DESIGN ADVISORY BOARD Tuesday February 25, 2020 at 3:00 PM Conference Room- Department of Permitting & Inspections, 645 Pine St, Burlington, VT

TO: Design Advisory Board
FROM: Ryan Morrison
DATE: February 25, 2020
RE: 20-0645CA; 96 Ferguson Ave

Request: Remove existing second floor of the northern addition and rebuild as a full height floor.

1. 20-0645CA; 96-98 Ferguson Ave (RL, Ward 5S) Donal Dugan

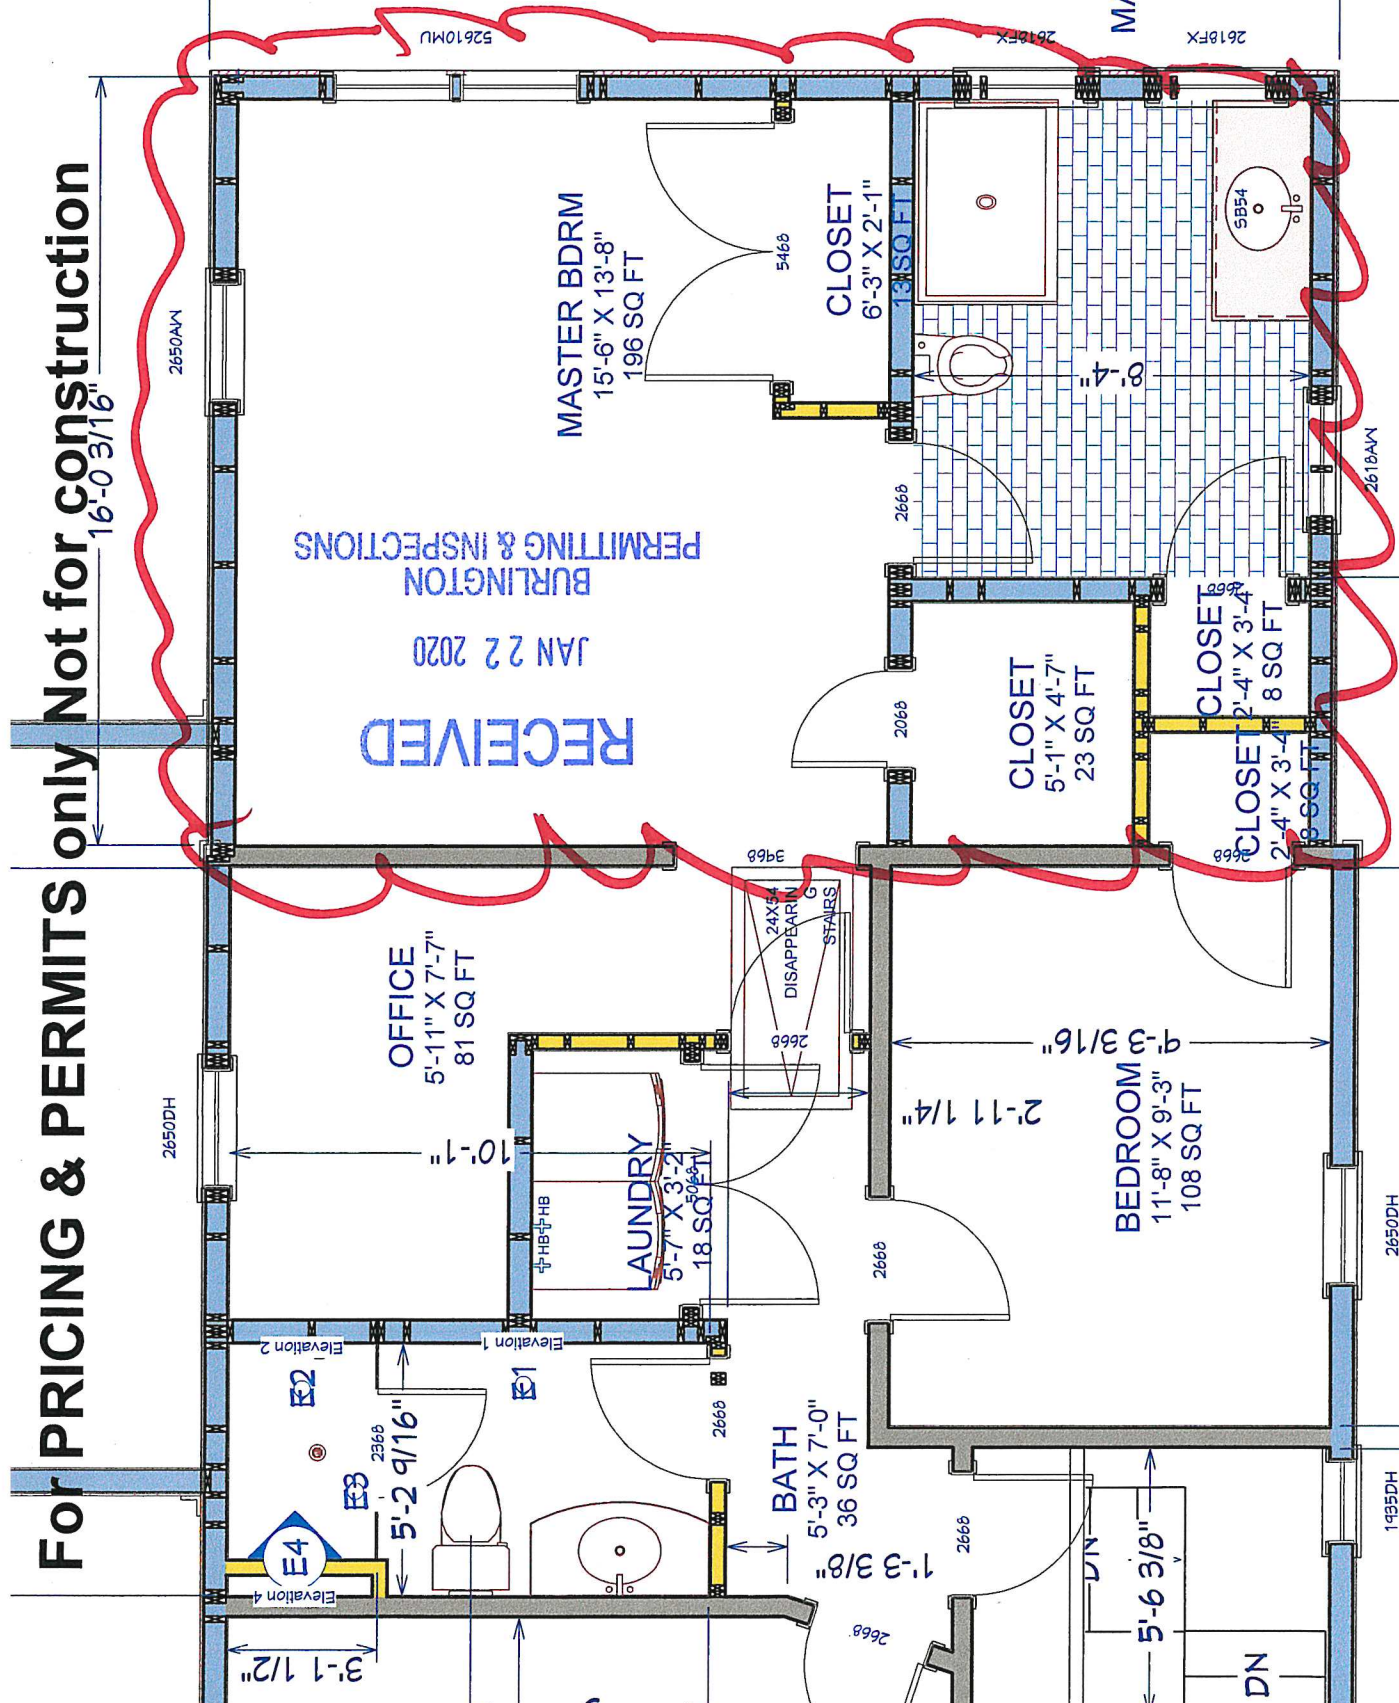
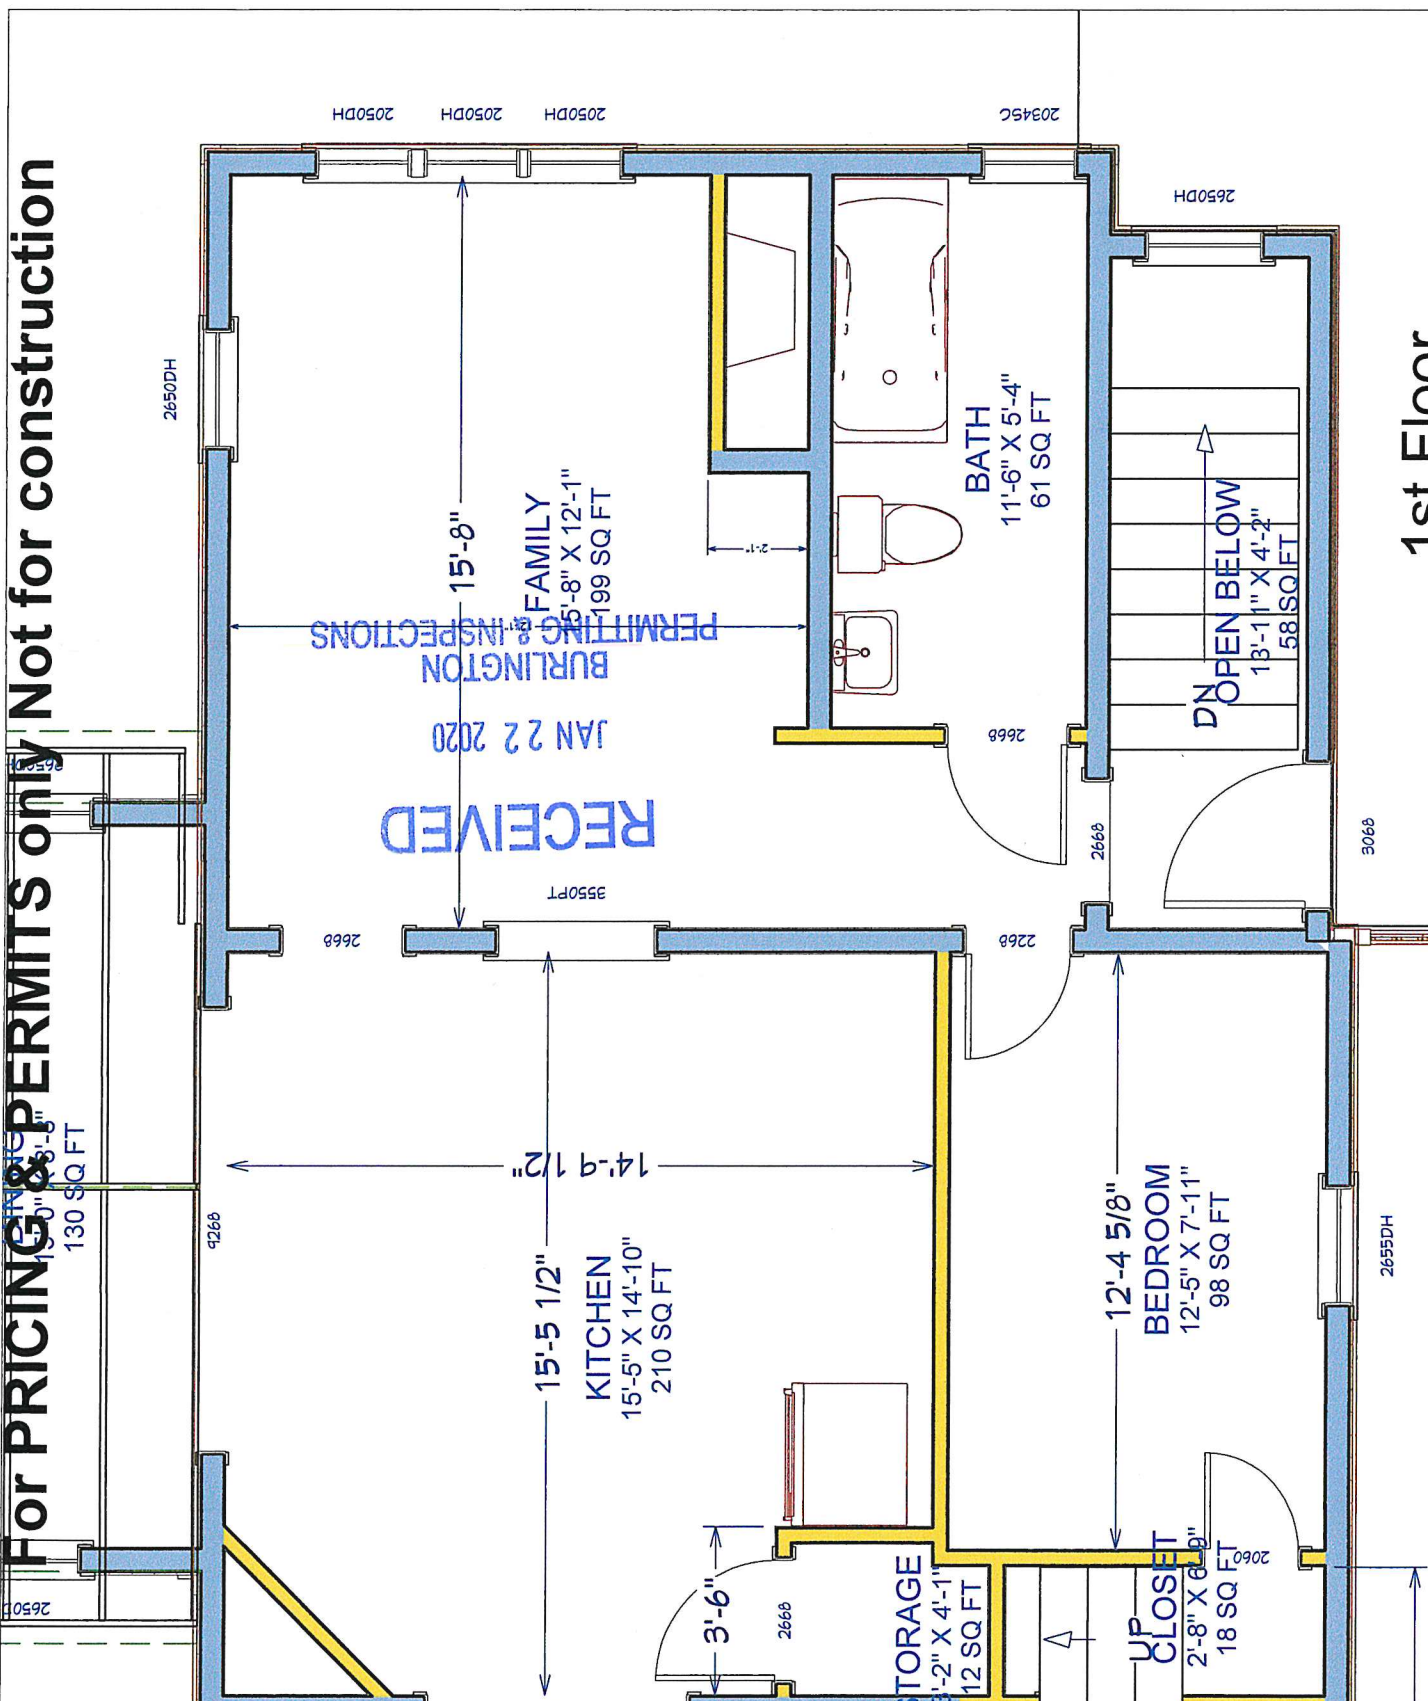
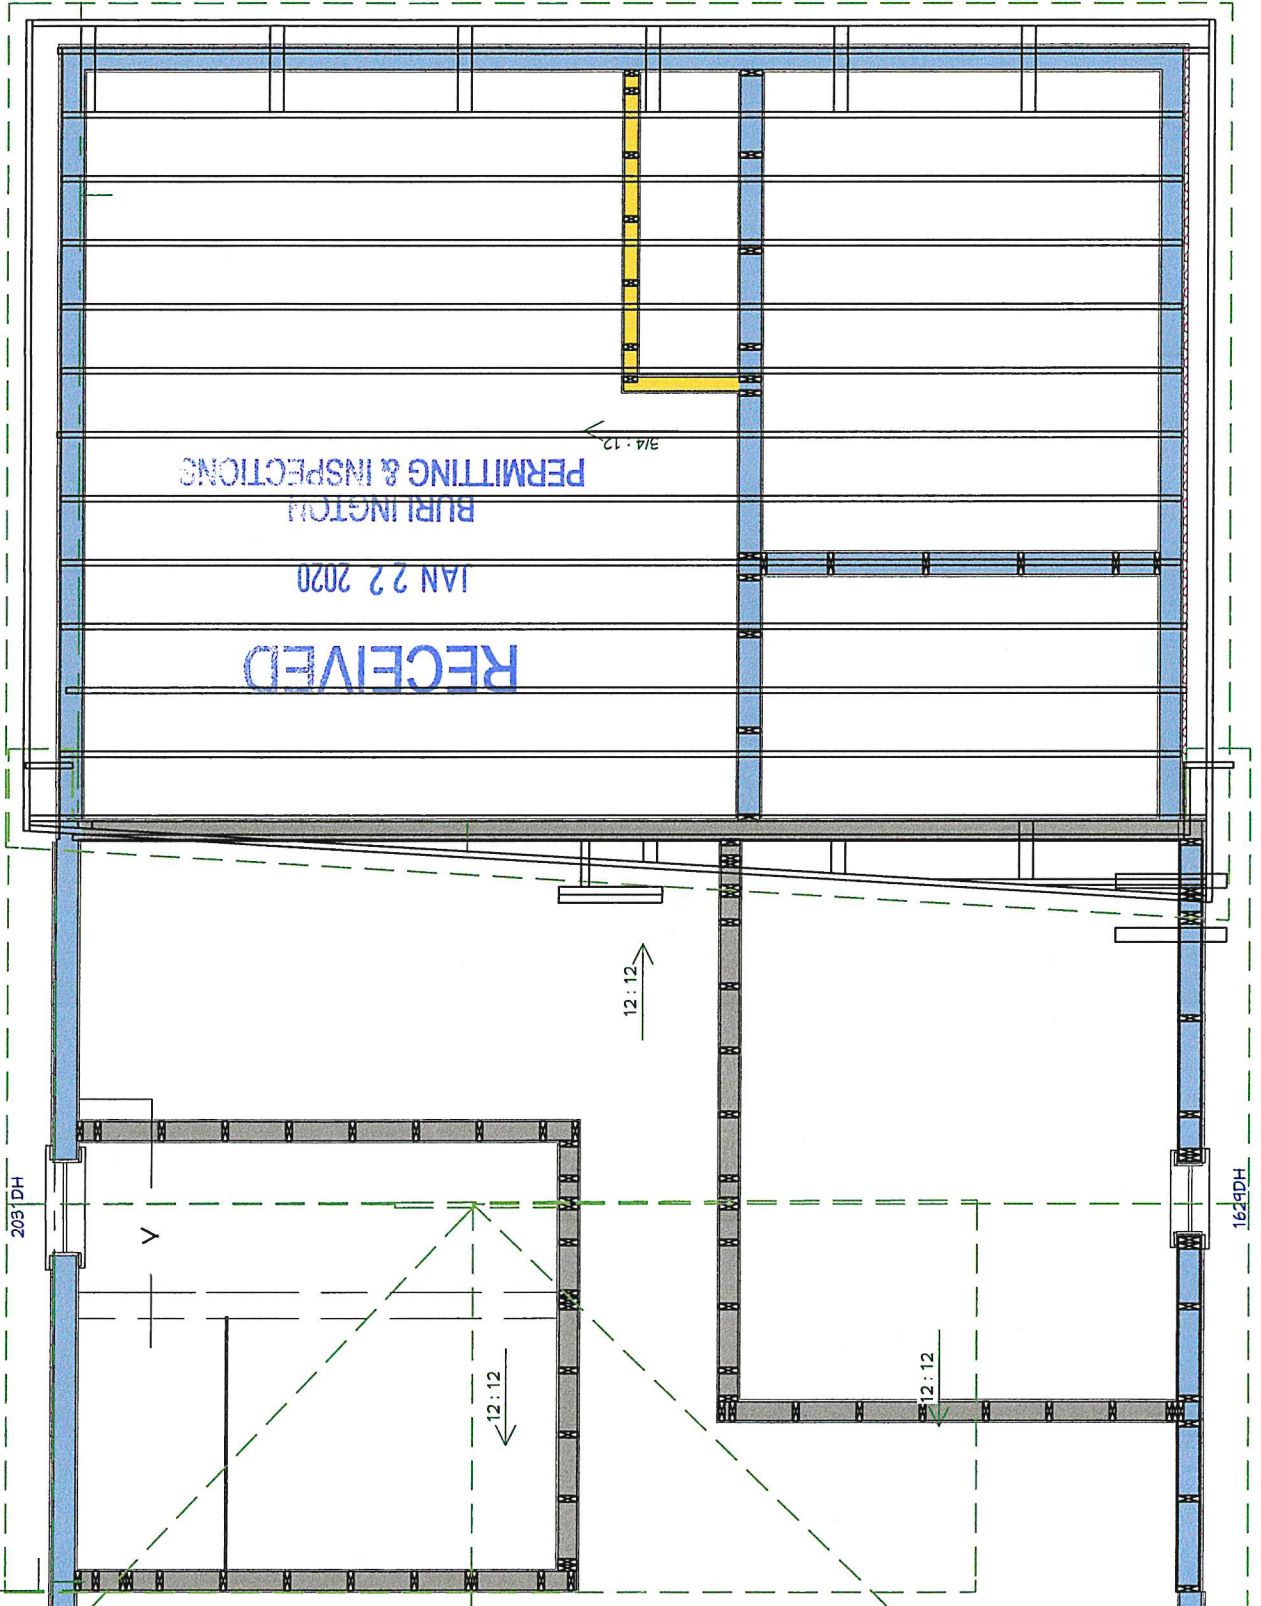
Proposed fenestration on the rear second floor will see larger windows along the walls of the bedroom to allow for more natural light, and smaller awning/fixed windows along the walls of the bathroom to allow for natural light while also taking privacy into account. The variety of window placement will be similar in appearance to that of the window placement on the first floor of this rear building section.

- Use the same Hardiboard siding on the 1st and 2nd floor.
- Use slate siding on the 1st floor and Hardiboard on the 2nd floor to lessen the perceived heaviness of the 2nd floor.
- Increase the slope of the roof by lowering the eave at the north edge.
- Bring the 2nd floor windows into alignment with the 1st floor windows. Use consistent window sizes.
- Add a frieze board under the addition's eave line to reduce the apparent height.
- Adjust the location of the 2nd floor trim board so the 2nd floor elevation does not appear taller than the 1st floor addition.
- Eliminate the 2nd floor transom windows.
- Explore elimination of the band between the 1st and 2nd floors.

1. Prior to release of the zoning permit, revised project plans addressing the following items shall be submitted, subject to staff review and approval:
 - a. Specification sheets for all proposed windows and roofing material.
 - b. Updated elevation drawings showing the proposed siding.
 - c. Details/spec sheets on the proposed siding to be used.
2. Standard permit conditions 1-15.
